Modular Housing Initiative – Trenton/Cedarvale Ave

Community Liaison Committee Meeting #2

Meeting Summary

SITE PLAN

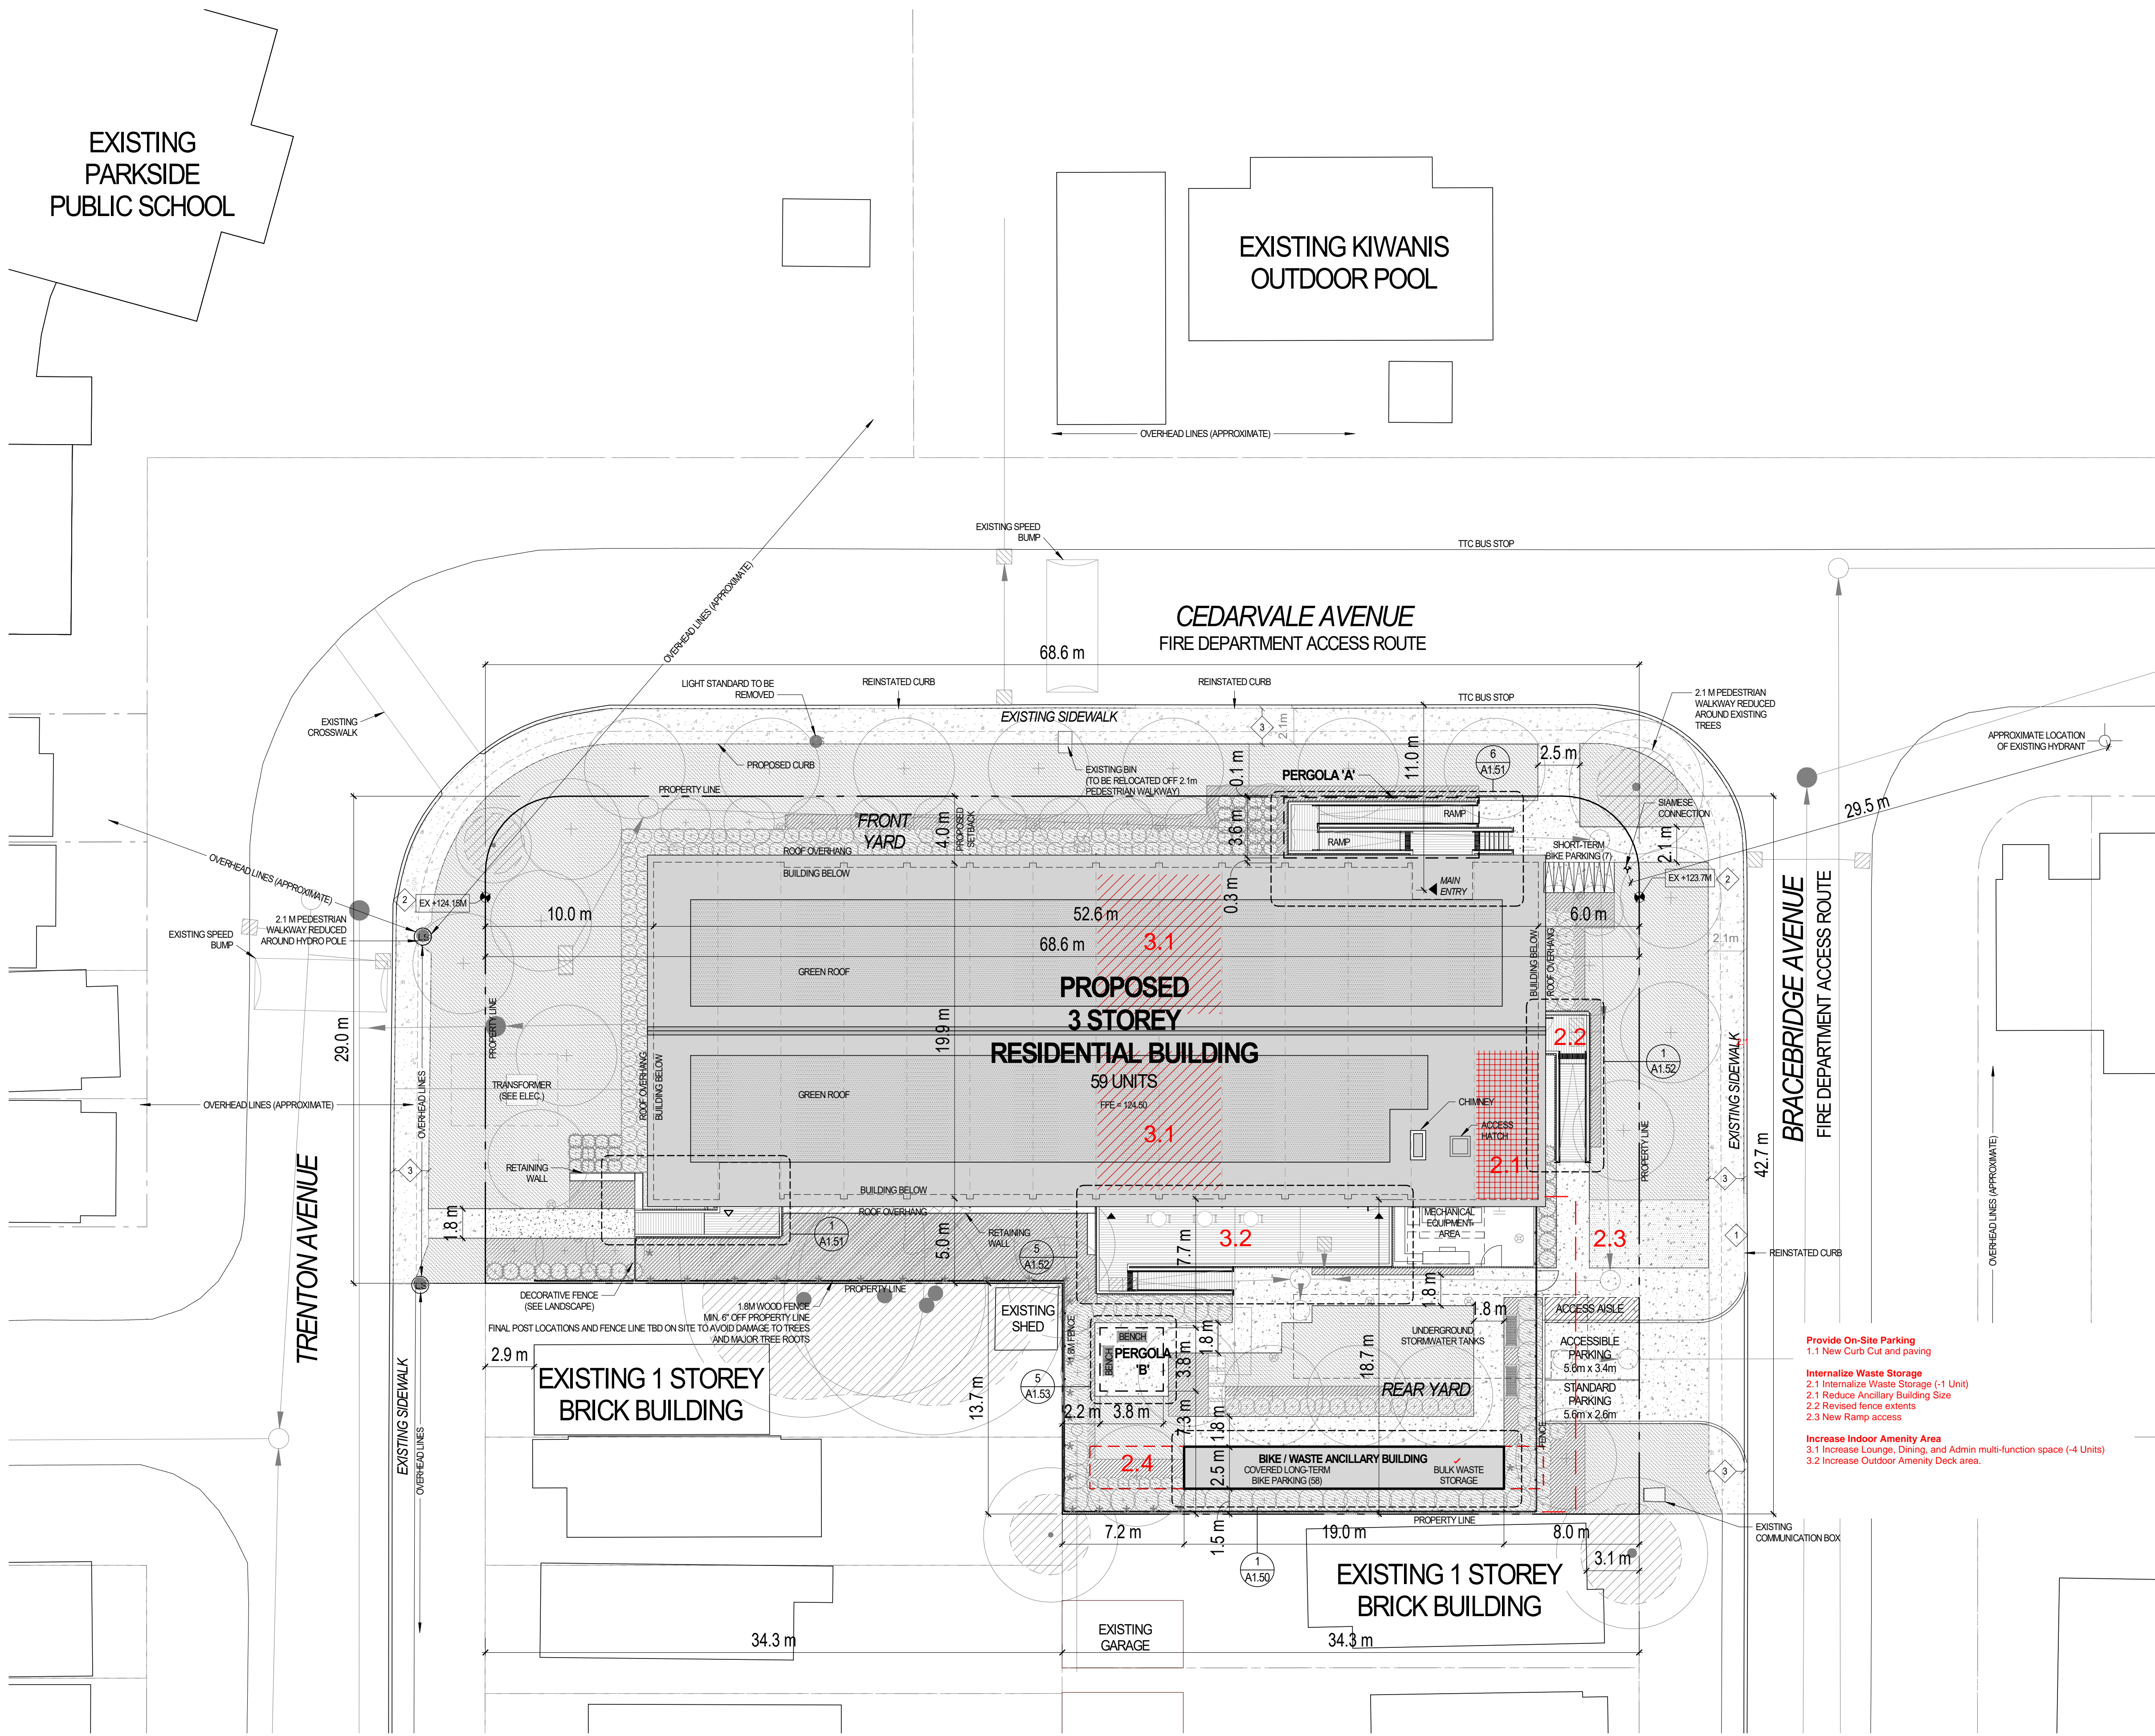
- **Provide on-site parking for staff:** Suggested to create one accessible parking space and one regular parking space, in the side yard space. This will require pushing back the former fence line, some additional paving and a new curb cut.
- **Internalize waste storage:** Removed one unit and replaced it as a waste storage room. We have also added a new deck and ramp to facilitate moving the waste from the waste room to the curb for pickup. The plan will be to push the fence back to accommodate this change. This all means that now we will have a relatively smaller sized ancillary building which will be used for long-term bike storage and temporarily storing large bulky waste items.
- **Increase indoor amenity area:** Removed four units in favour of expanding the amenities space and admin support space. This has allowed us to also increase the outdoor amenity deck area.

Q: How is the issue of parking in relation to emergency services vehicles going to be addressed? How might this impact the residents?

Q: Can the bulk waste storage proposed for the ancillary building not be used for garbage, as it is next to a neighbour's property?

A: Generally, on-street lay-bys are not preferred from a traffic management perspective. City staff agreed that accounting for emergency service vehicles and pick-up/drop-offs needs to be considered and will be looking to gather feedback from the Phase 1 providers about their experiences.

A: The decision to use the ancillary building for bulk waste has not been finalized. The proposed intent of the bulk waste storage is not meant for food or garbage waste but rather bulky items such as furniture or long-term bike storage. It would be the property manager on site who will be responsible for the final disposal of the items such that they do not affect other neighbours in any way.

LEVEL 1 & 2 PLANS

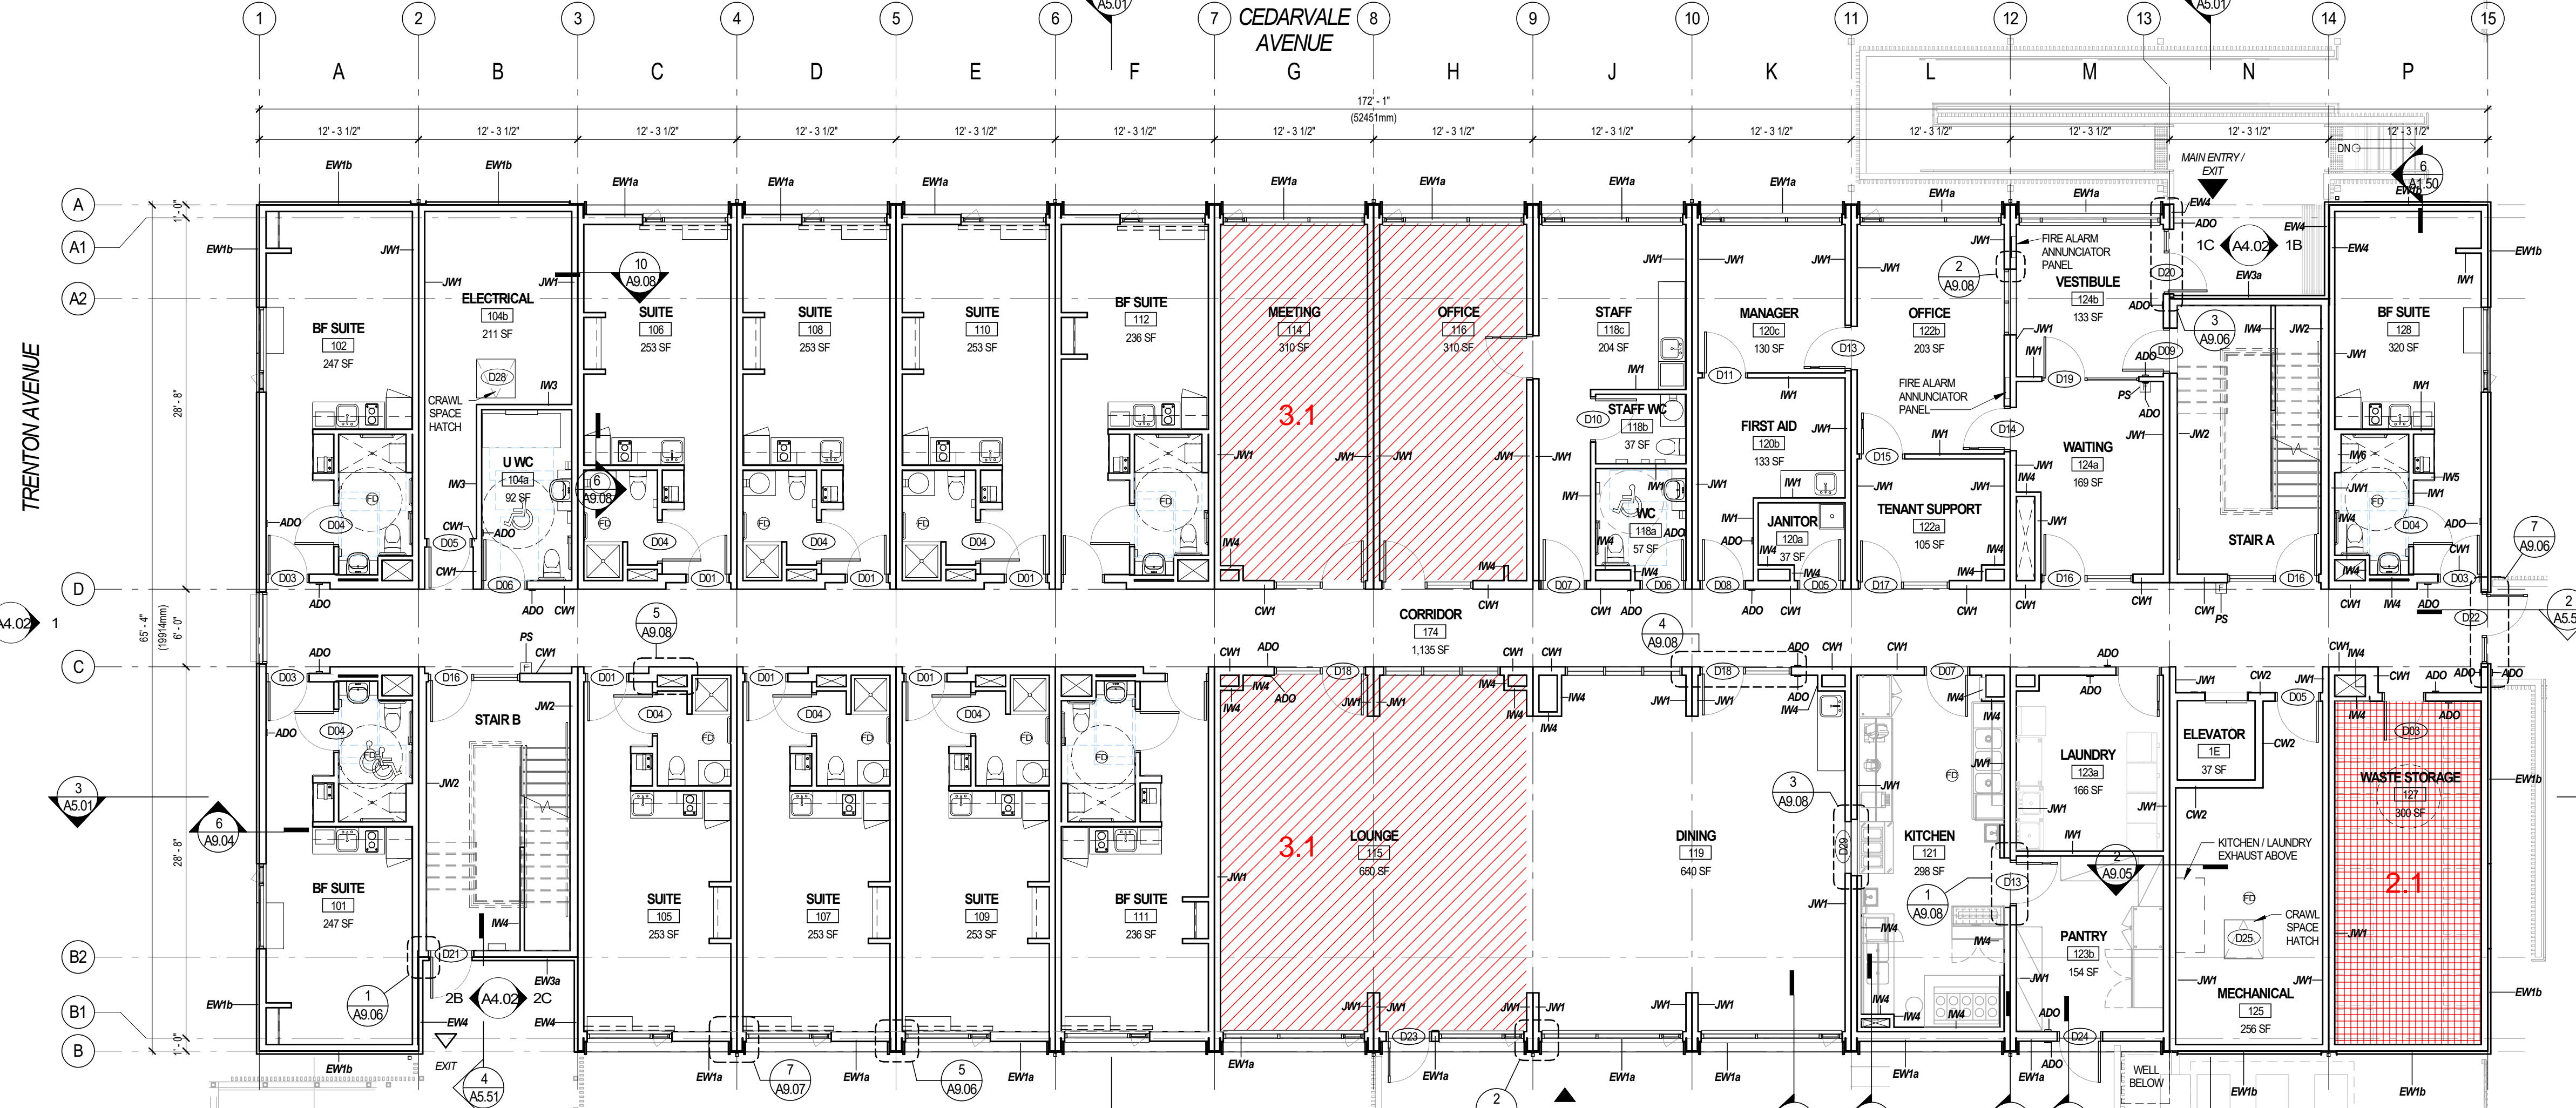
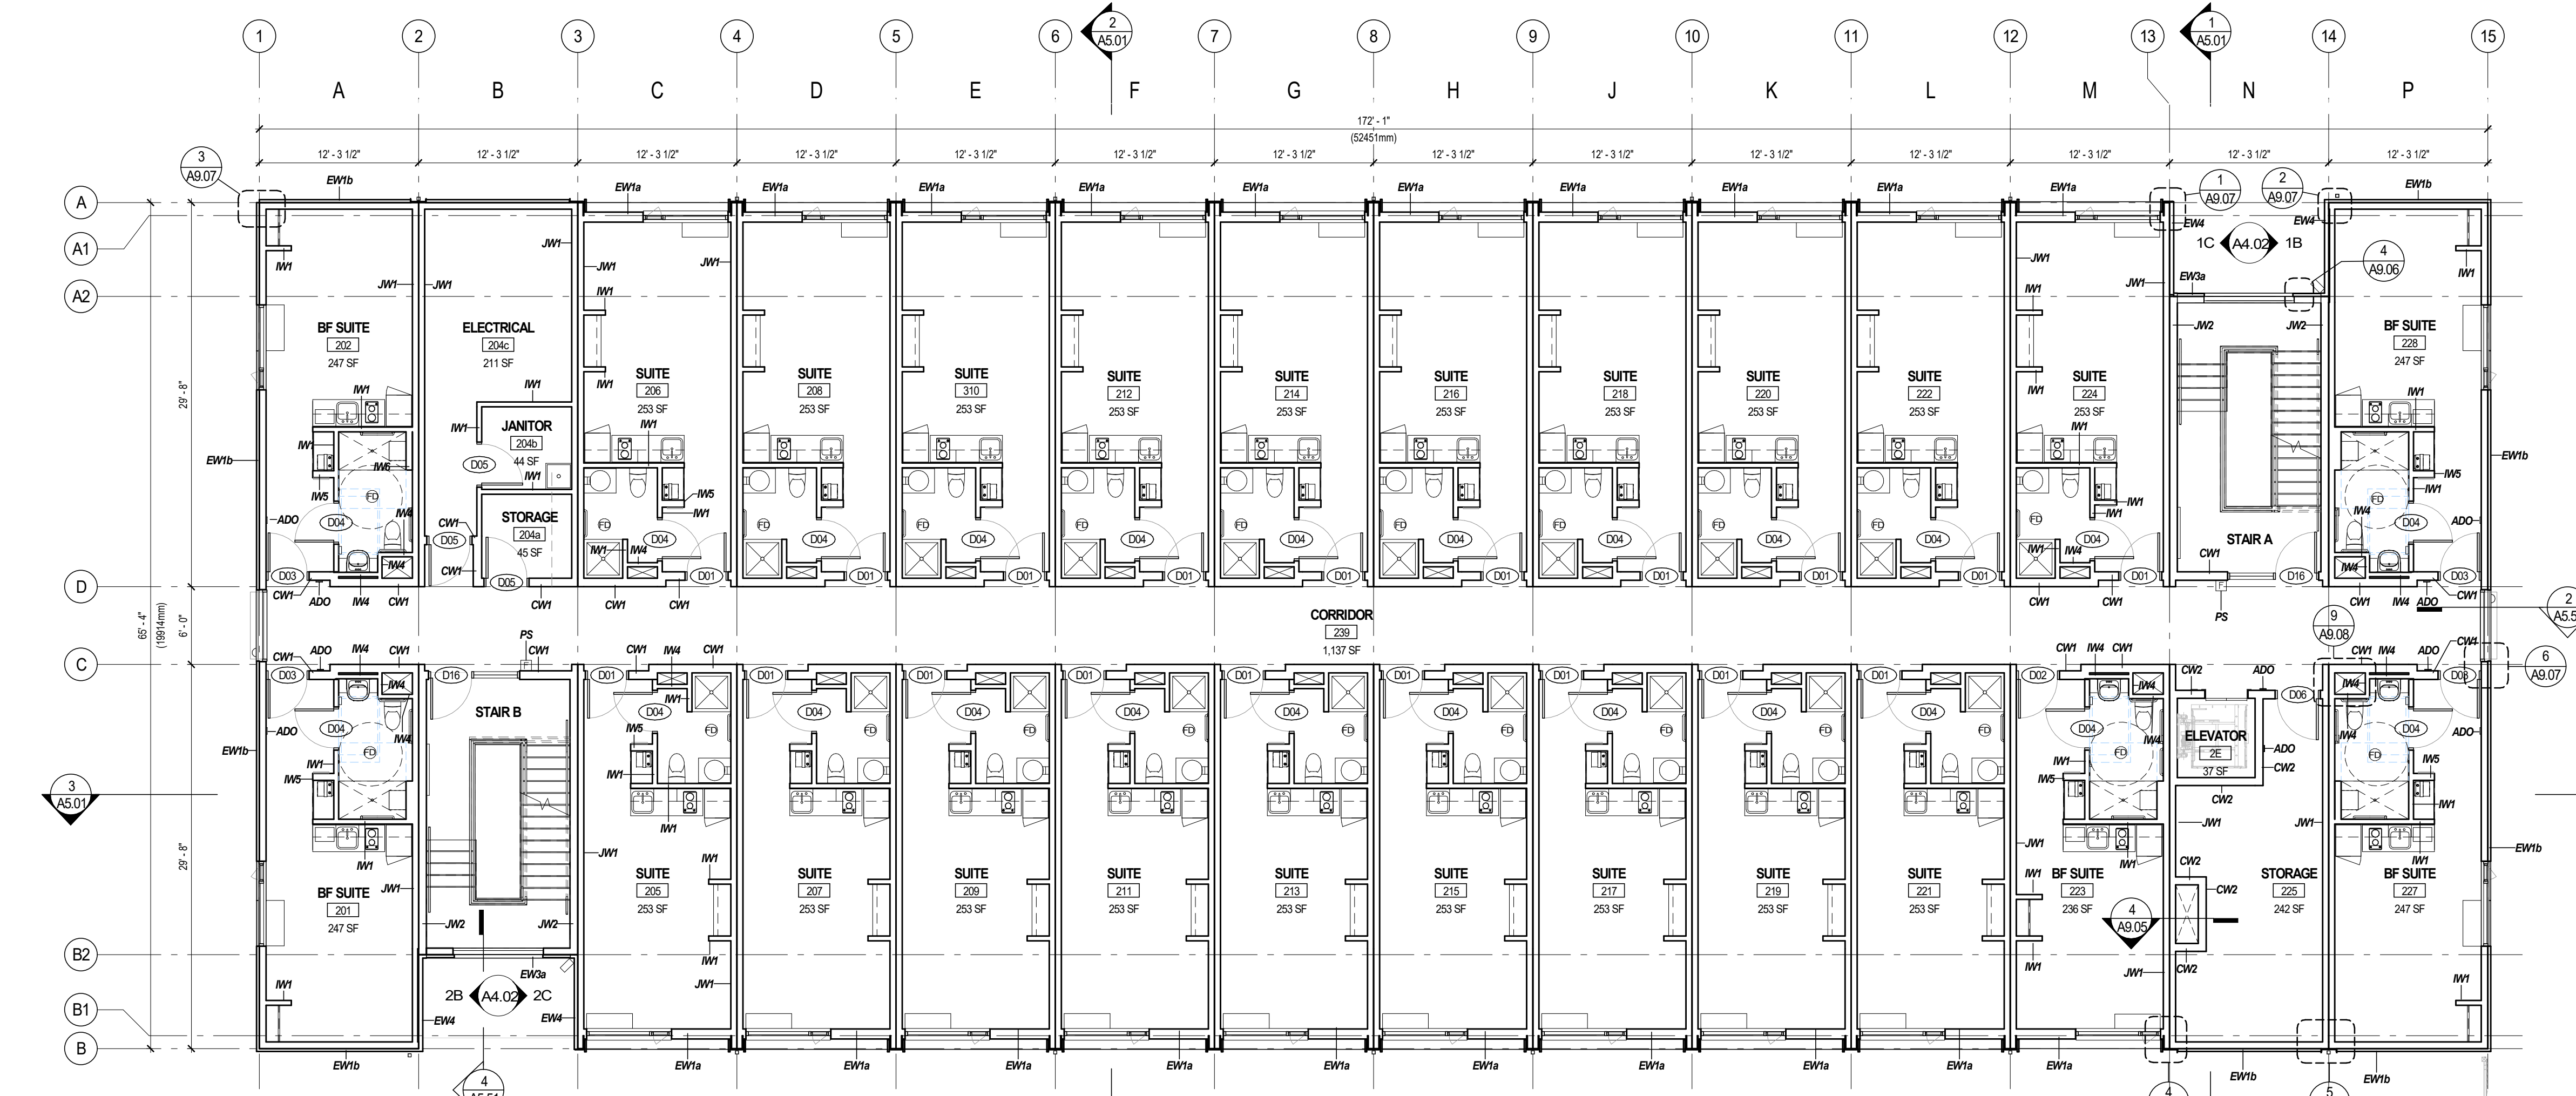
Q: Are there any guidelines with respect to placing units next to waste storage? Is it fine to have a unit next to the waste storage and if not, can it be relocated?

Q: Does the lounge take up four units or two units?

Q: Can some of the office space (Room 116, Room 122b) be allocated to tenant support space since the space for tenant support is only 170sqft?

C: The space being proposed for lounge, dining room and kitchen is not sufficient and will result in overcrowding. We need to reduce the number of units by five and add an additional space to the lounge and especially the dining room as well as expand the kitchen space to allow for more social distancing to accommodate COVID-19 health and safety protocols.

A: This set-up is seen in other building forms as well, including condominiums and long-term care facilities. We are working on updates to the mechanical system to mitigate noise and smell. This includes things like ensuring a negative pressurized waste storage room so smells do not spill out of the room.

A: The lounge occupies the area where two units were previously located.

A: The office space is used for staff. The tenant support space is used for one tenant and one staff at a time, to have one-on-one discussions. Tenant supports will also be provided in tenants' apartments and communal spaces. There is also flexibility for the selected housing operator to decide how to use spaces for tenant supports.

A: The application has been reviewed and adheres to all indoor amenity space requirements. The proposed space currently meets the requirement of two meters square per unit. We also
